NILES GATEWAY MIXED-USE PROJECT

Final Environmental Impact Report
SCH # 2018012041

Prepared for
City of Fremont

September 2018

Figure 4.A-11
CRAFT Building Materials and Colors

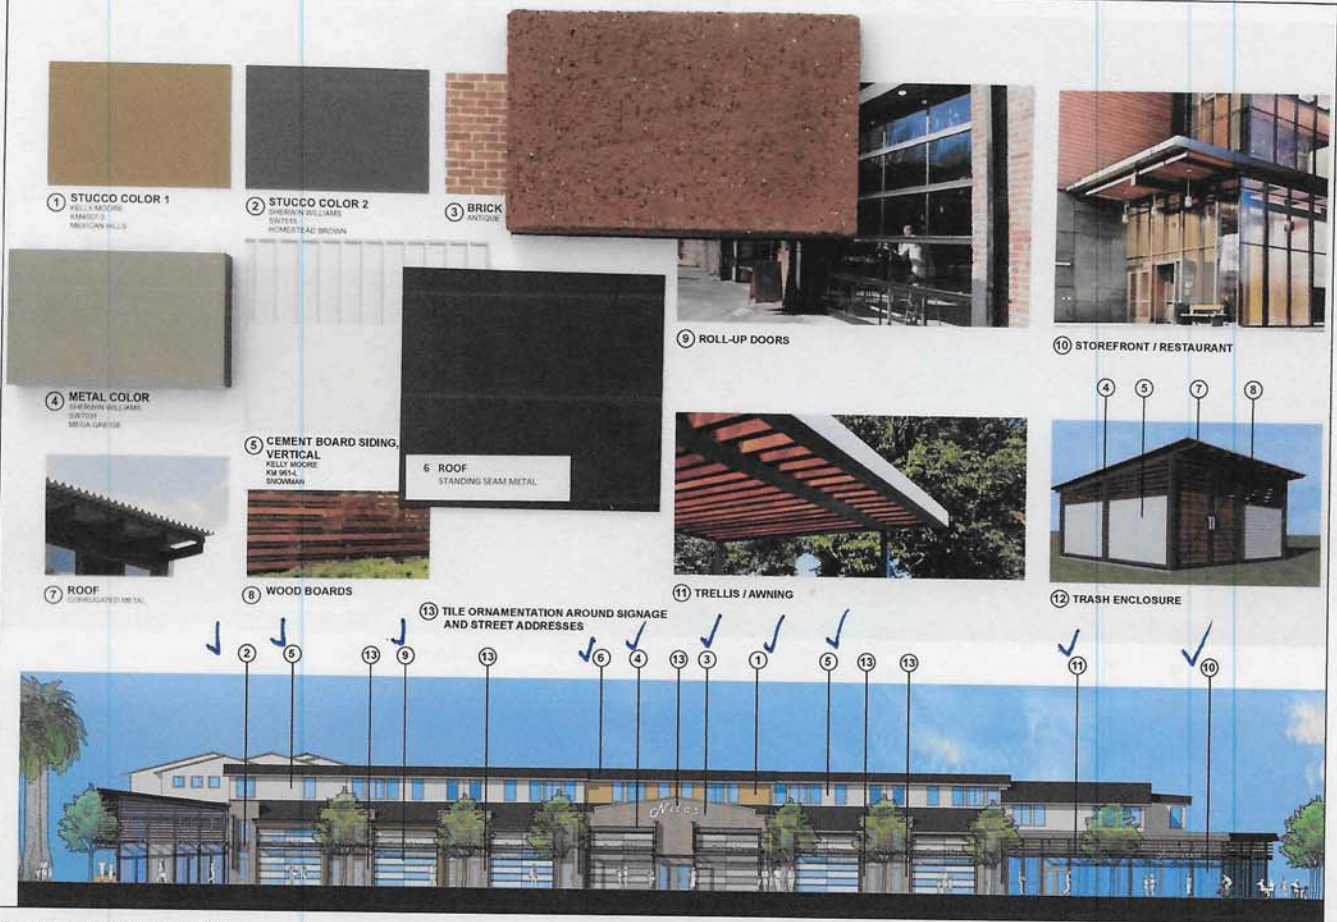
#5 was metal panel.
#13 new - no photo of sample.

10-1 The comment states that the project’s proposed material and color palette has not changed substantially from that of the previously approved project on the same site, despite the sponsor’s statements to the contrary. The comment also states that the proposed project would block views from the Alameda Creek Trail of the hills to the east. The comment also states that the rendering in Draft EIR Figure 4.A-16 inaccurately depicts the proposed project. Finally, the comment expresses dissatisfaction with the project’s architectural style.

*Poster
Exhibit
C.1*

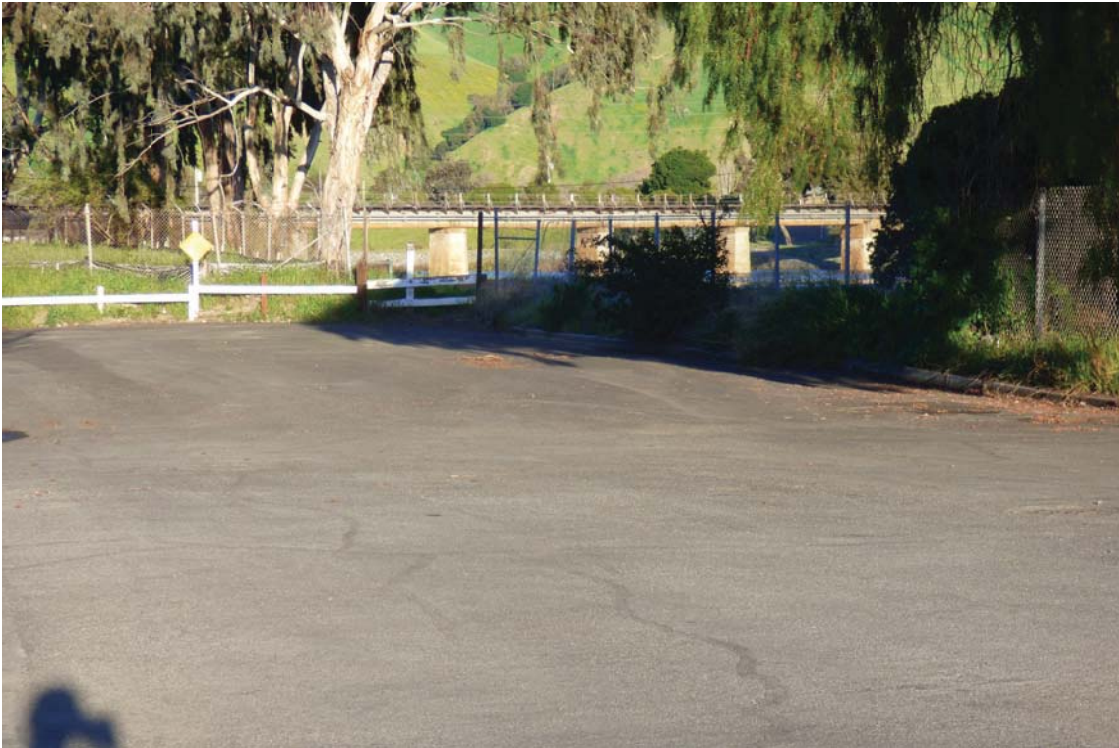
Regarding Figure 4.A-16, as described on page 4.A-35 of the Draft EIR, the digital renderings represented in Figures 4.A-16 through 4.A-20 do not comprise photorealistic simulations of the proposed project; the purpose of the digital renderings is to provide the viewer with a general visual sense of the design, colors, and massing of the proposed project and its relation to existing views of the project site.

Figure 3-7 (revised)
Townhome Building Sections

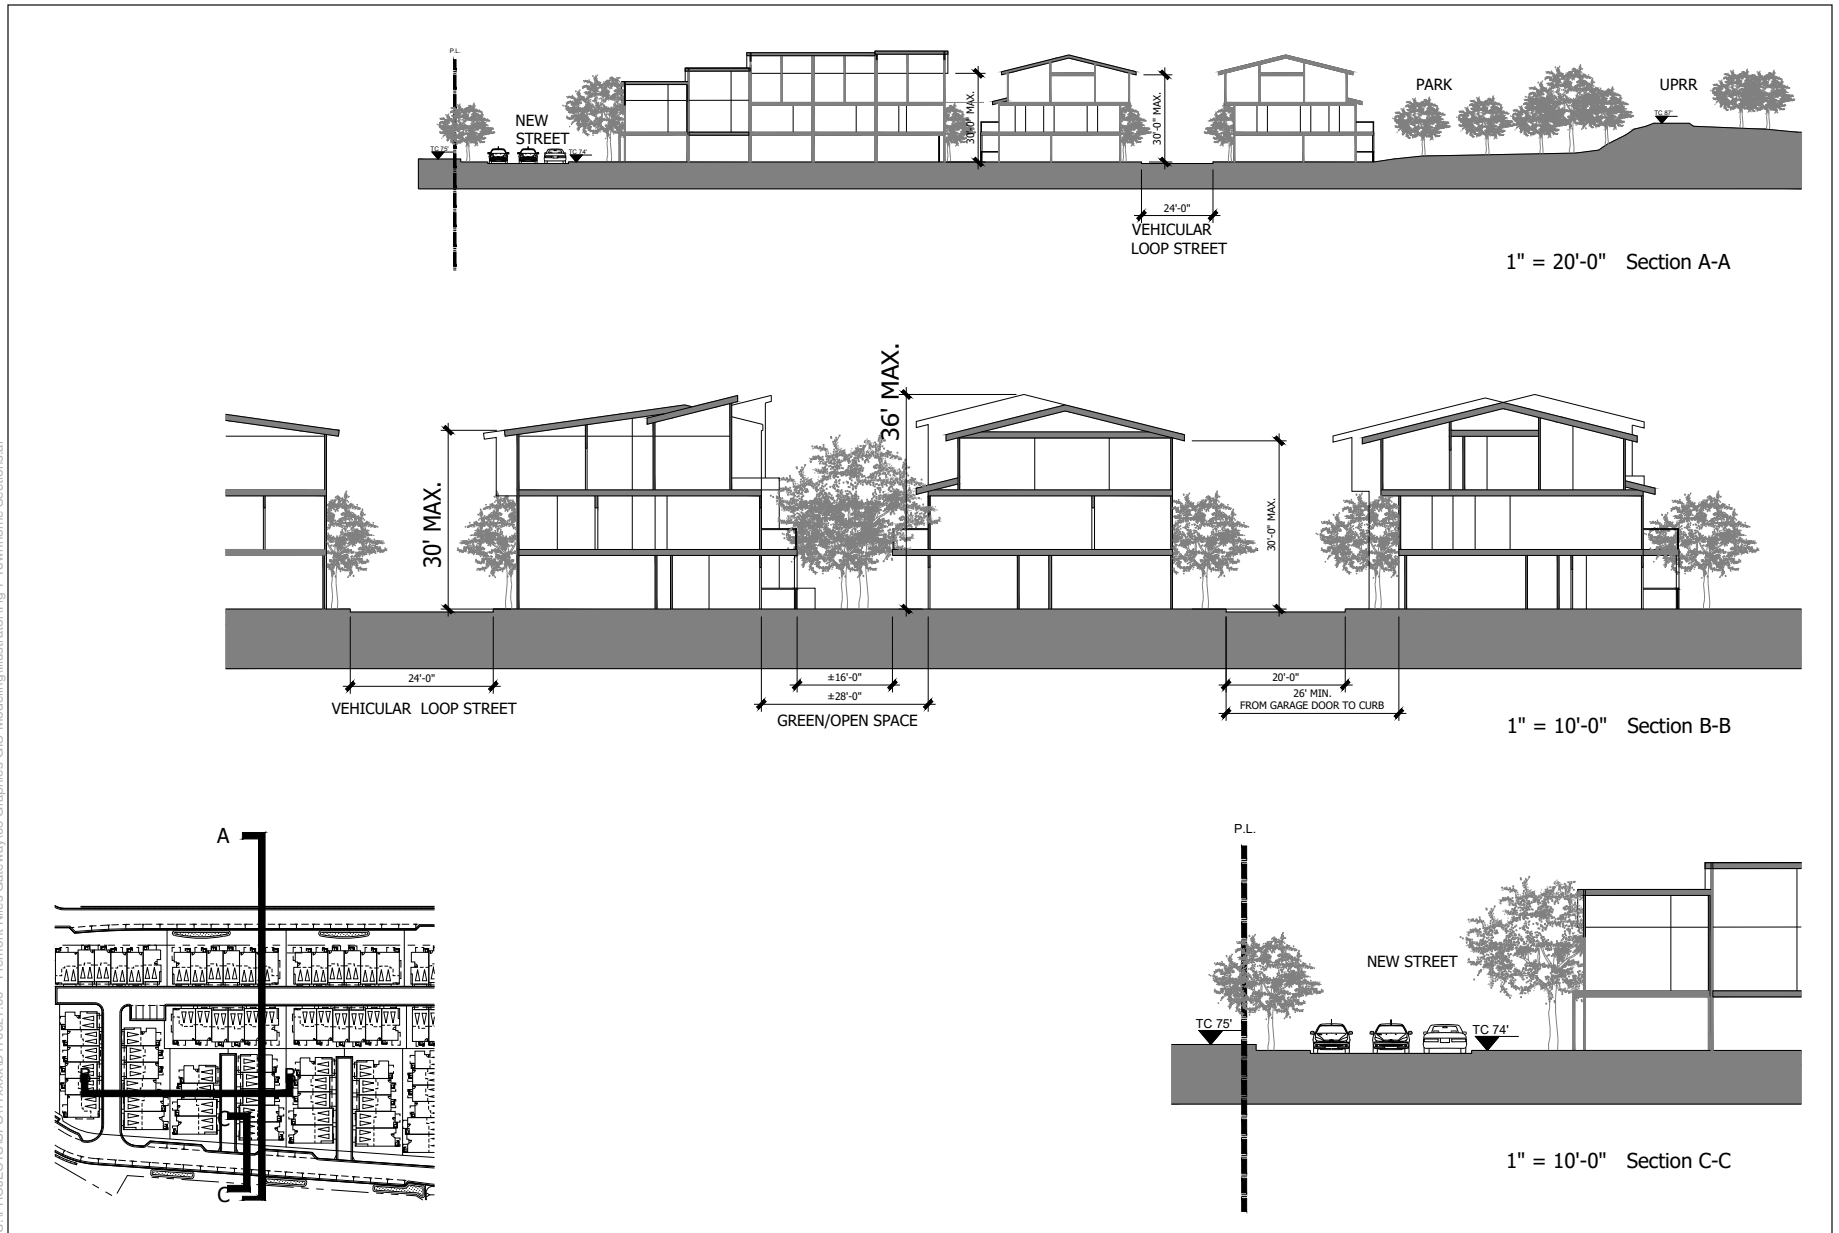
Figure 3-7 on page 3-13 of the Draft EIR is revised as follows (see next page) to include the maximum building height. This does not change the analysis or conclusion in the Draft EIR:
